## **ADDENDUM**

**PROJECT:** Forestside Estates  
Attmar & Palleschi Drive  
Brampton, Ontario

**PROJECT NO.:** 18-017

**ADDENDUM NO.** E-3

| 4TH FLOOR PLAN<br>ELECTRICAL                  |         |         |    |

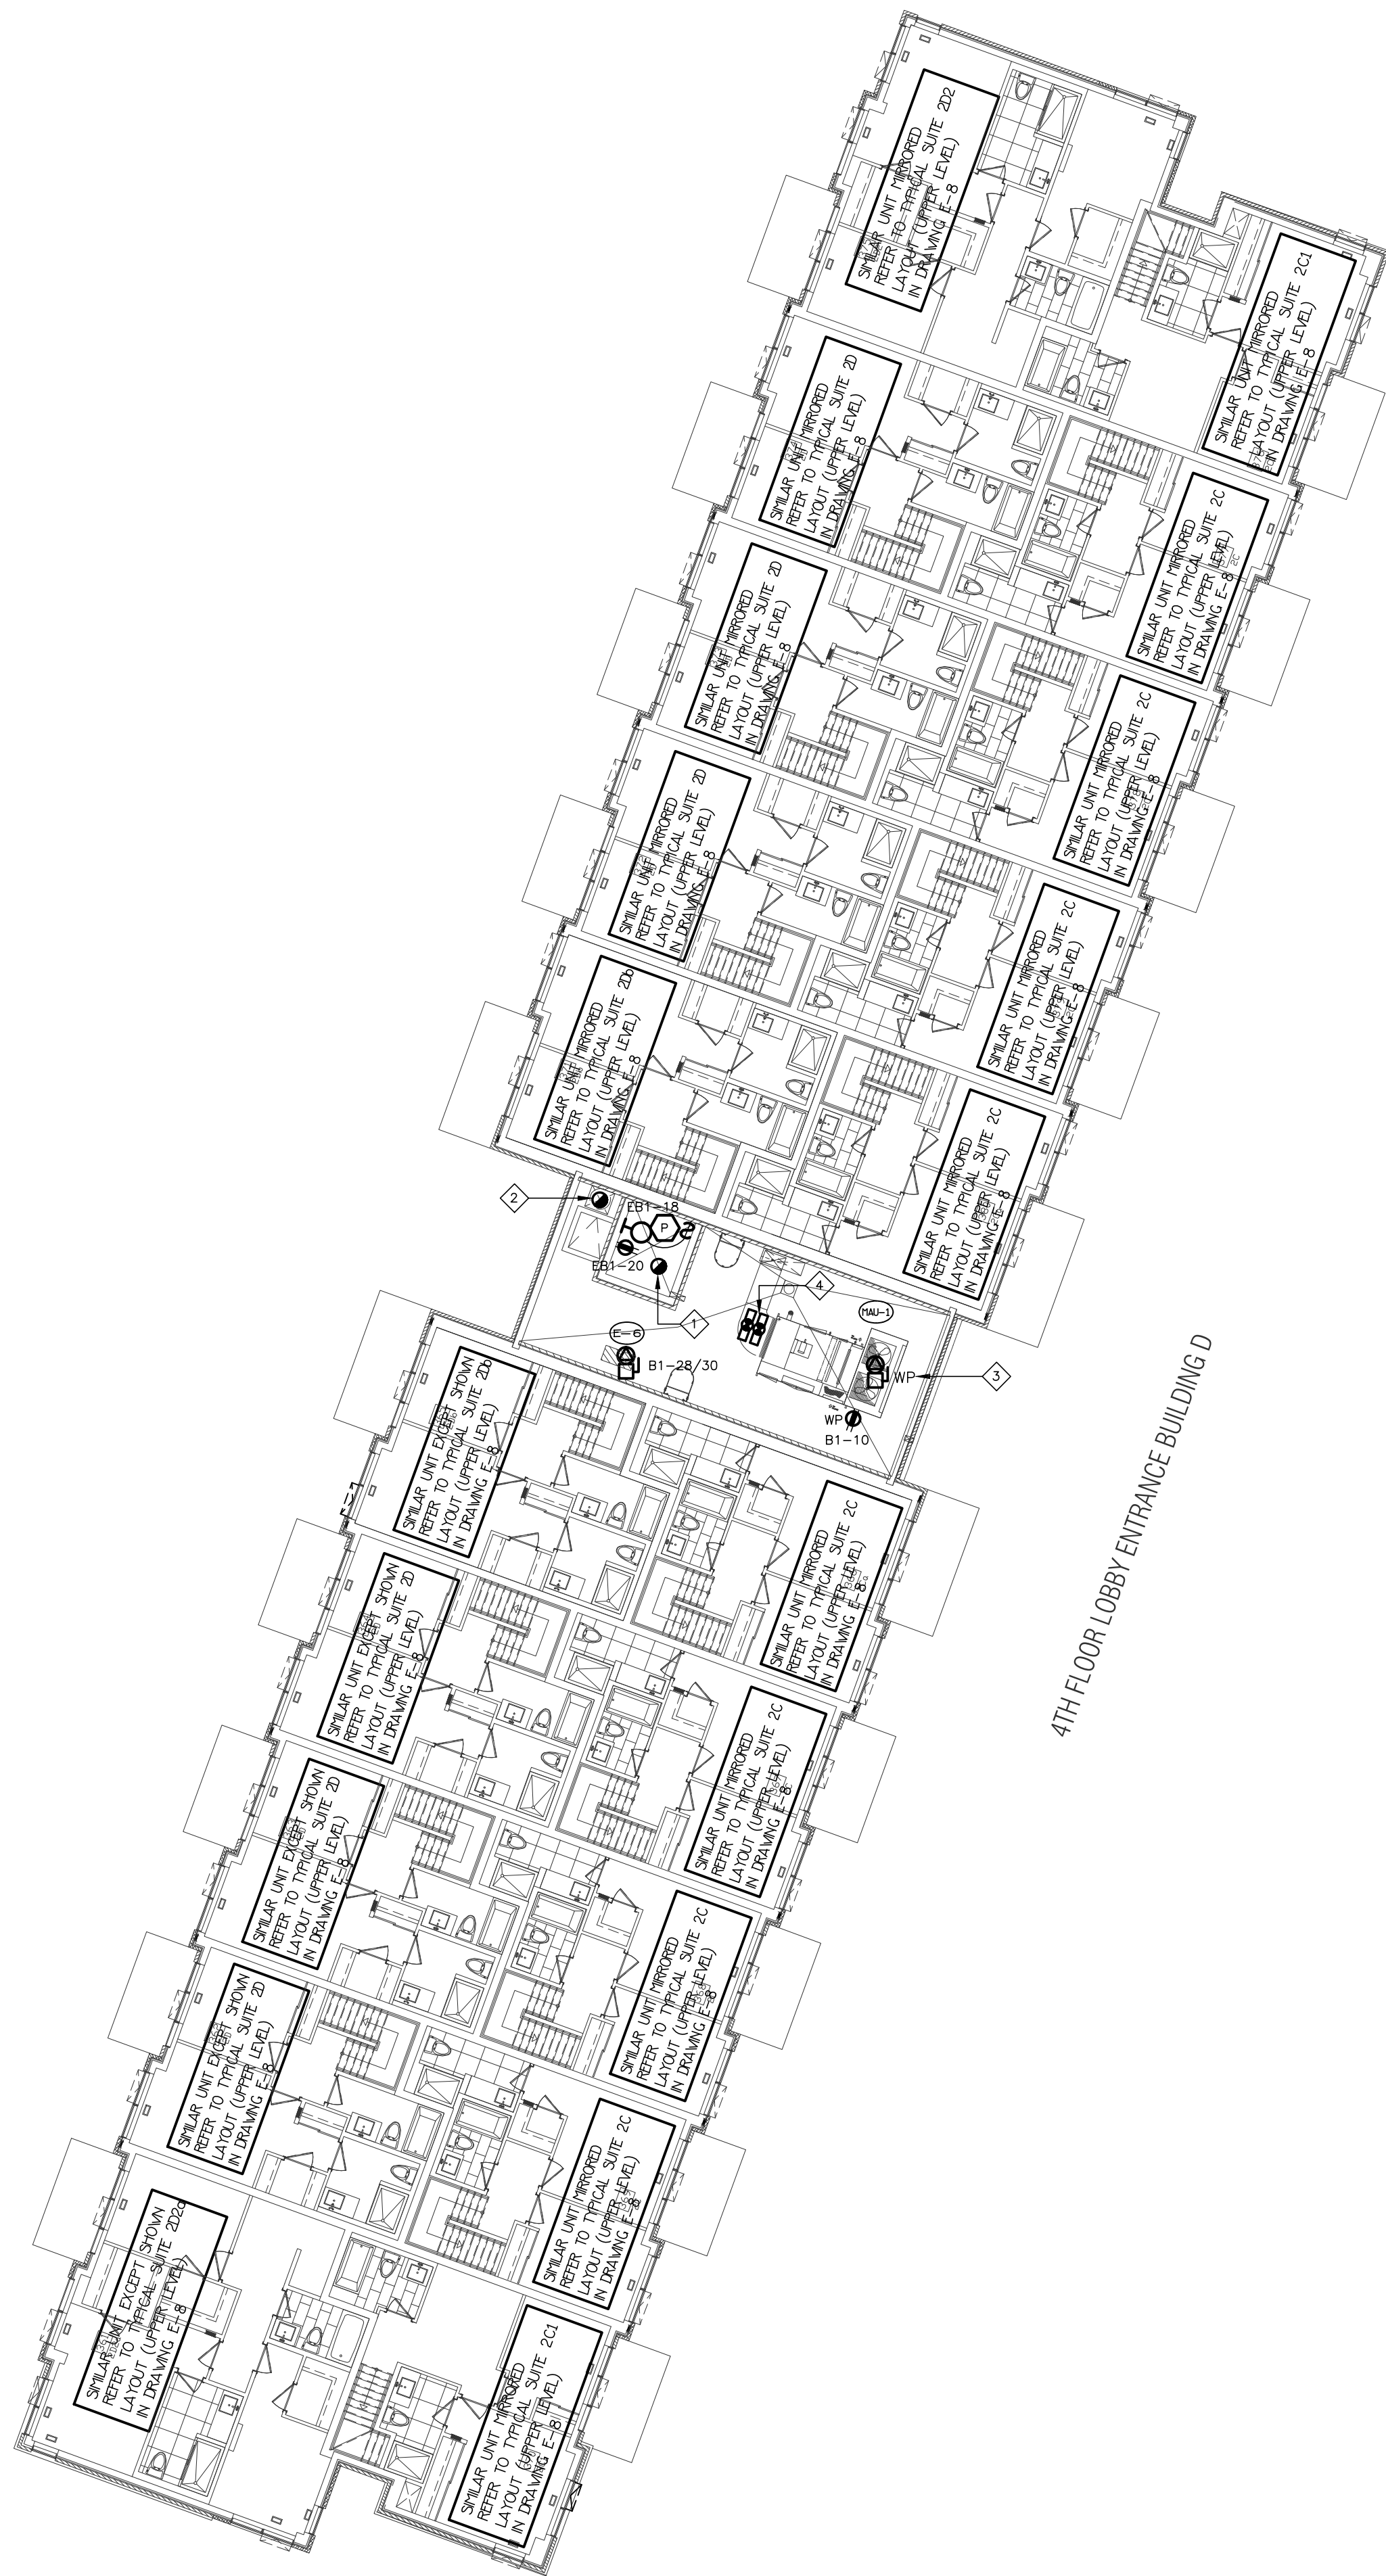
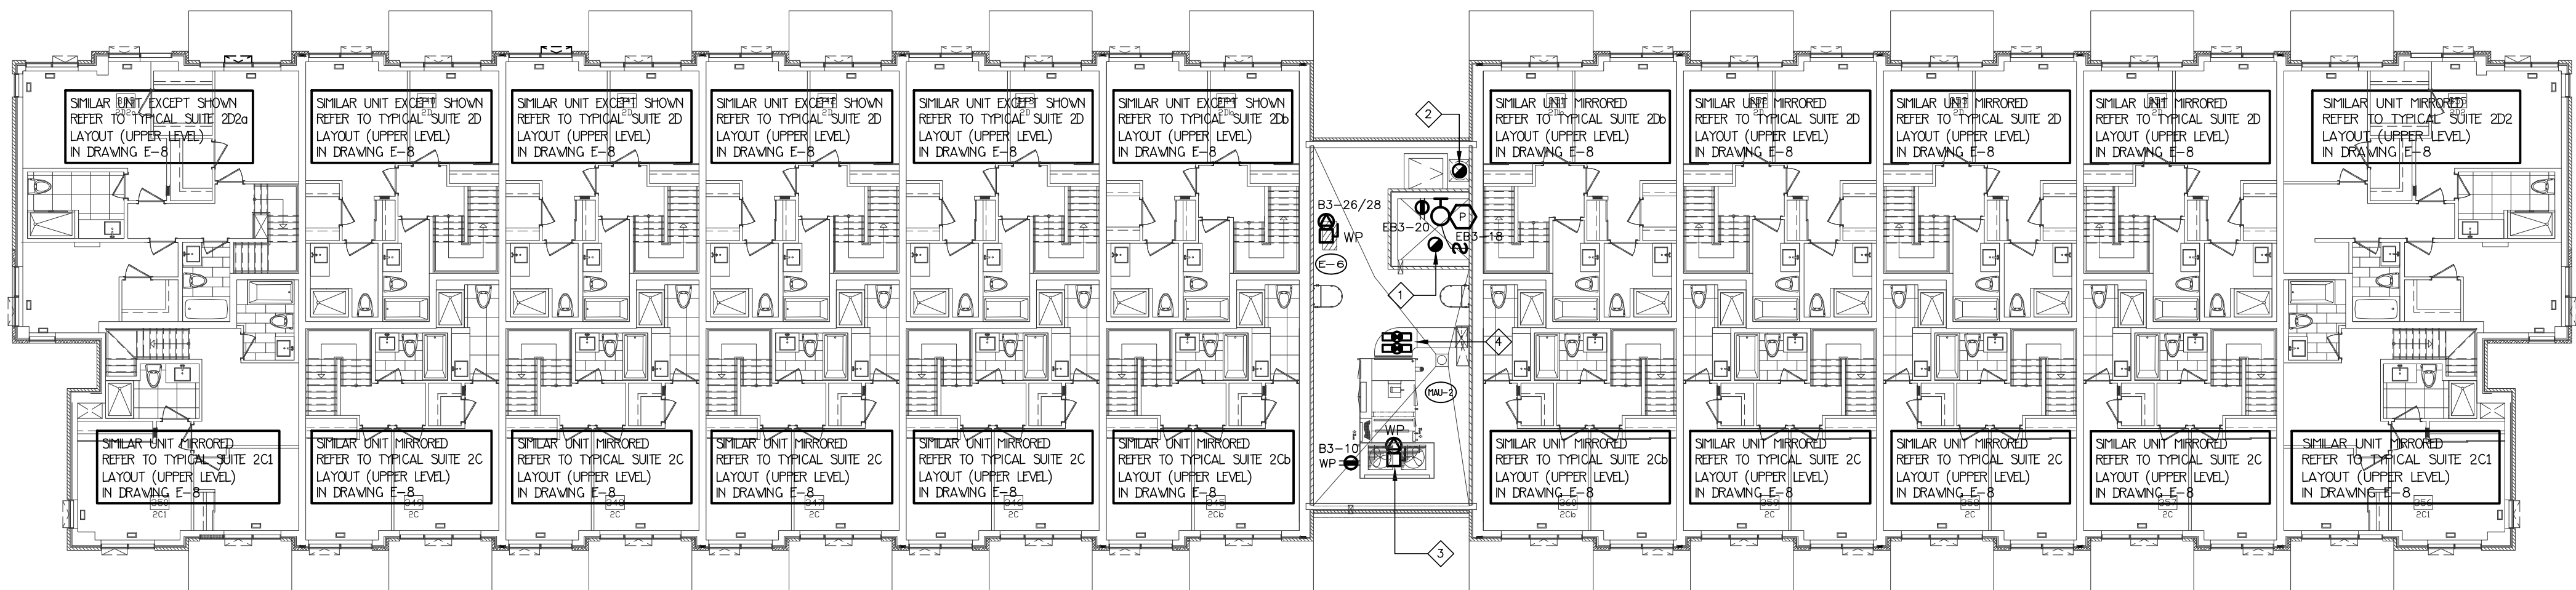
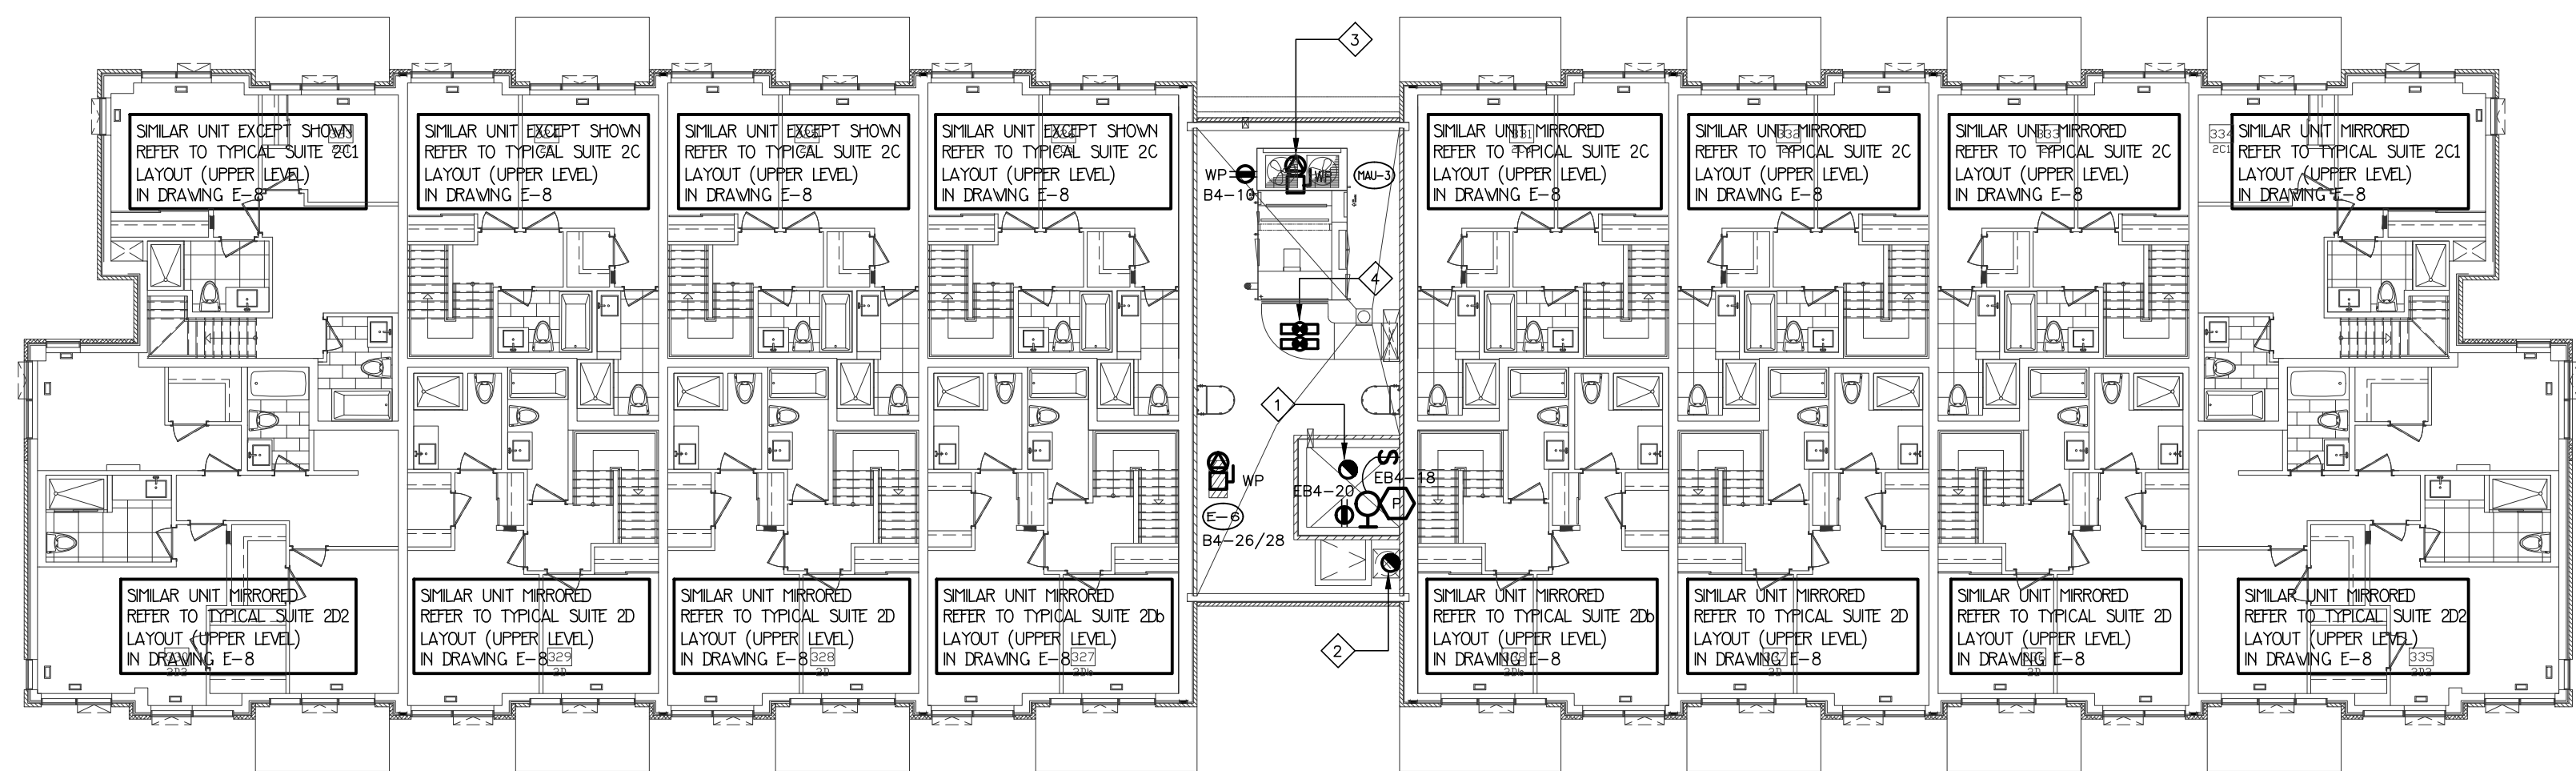
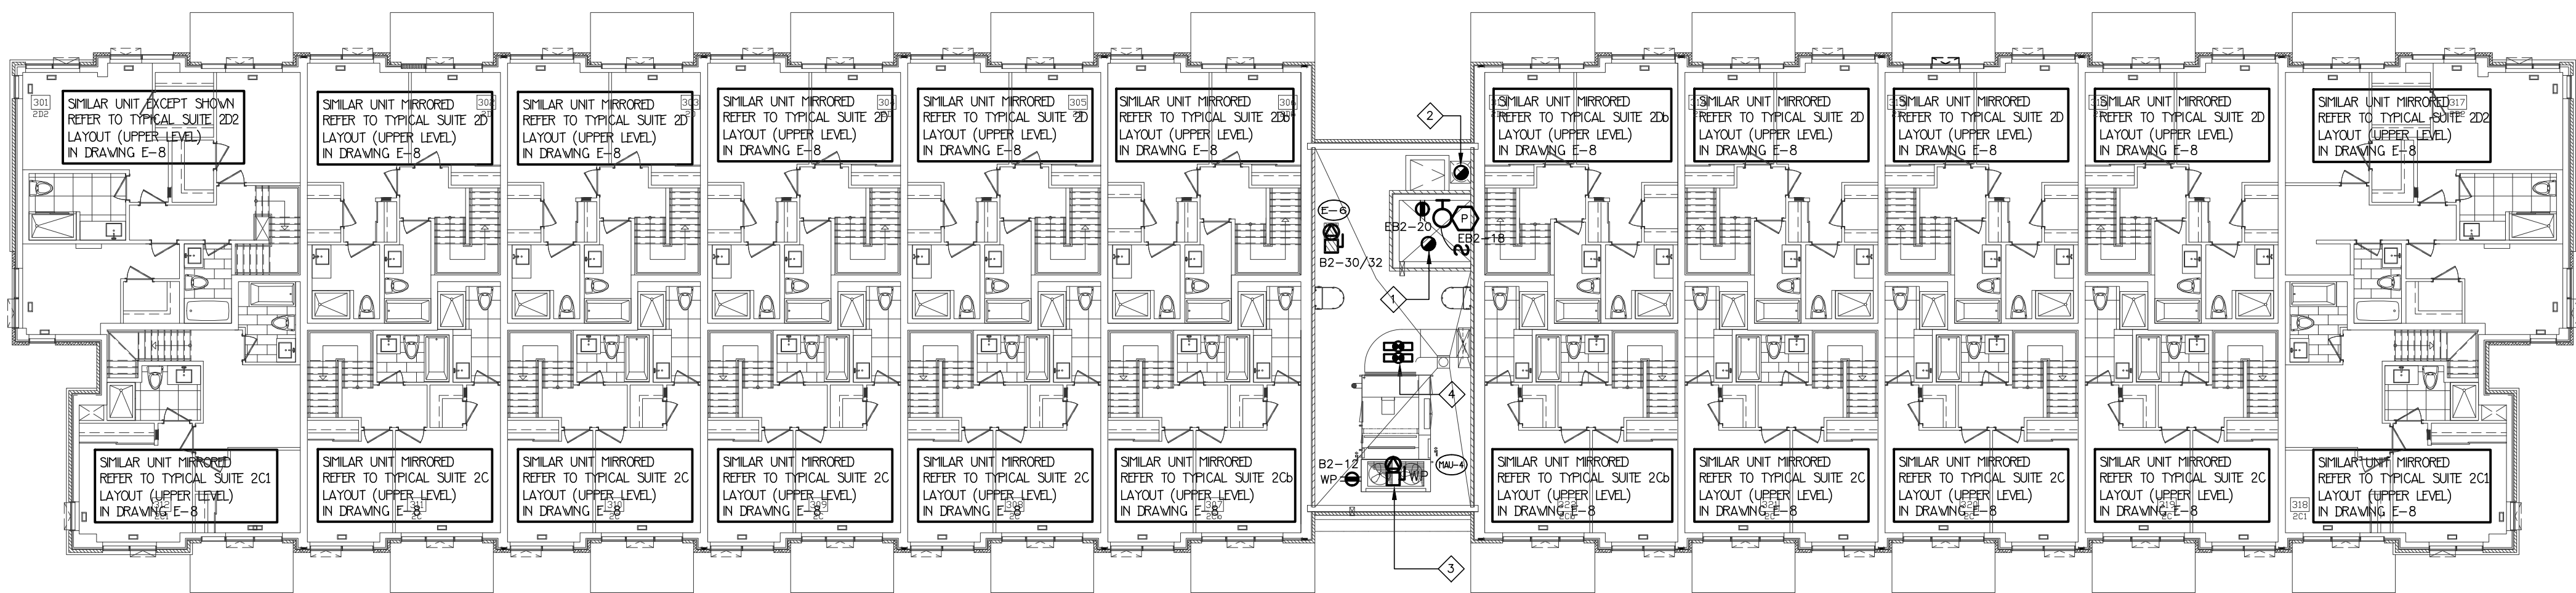
**2.0 Reference Drawings E-3 (Ground Floor - Electrical) Issued**  
**E-4 (2<sup>nd</sup> Floor- Electrical)**  
**E-5 (3<sup>rd</sup> Floor- Electrical)**  
**E-6 (4<sup>th</sup> Floor- Electrical)**  
**E-7 (Roof- Electrical)**

2.1 Revise: Unit type for building C block 6 to suit latest arch drawings as shown

2.2 Revise: Unit numbering to suit latest arch drawings as shown
